CHUGACH ELECTRIC ASSOCIATION, INC.  
Anchorage, Alaska

ADDENDUM #1

P1900043 – Gambell Street Undergrounding: 3<sup>rd</sup> to 16<sup>th</sup> Avenue  
E2320071 – Gambell Street Transmission Pole Relocate  
GCI – Joint-work  
ACS – Joint-work

Roadway

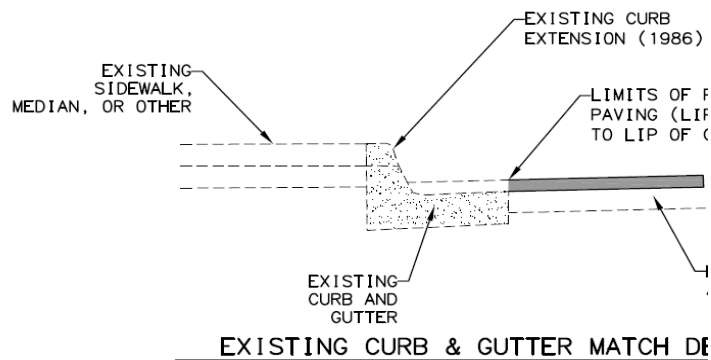
The Contractor to restore the roadway structural section (if disturbed) with the following:

- HMA, Type VH, PG 64-40 (match existing pavement thickness with 2"-3" (max.) lifts, with STE-1 tack coat between each pavement lift)
- 2" Crushed Aggregate Base Course, D-1
- Select Material, Type A (36" (min.))
- Bedding material (as defined by the utility)
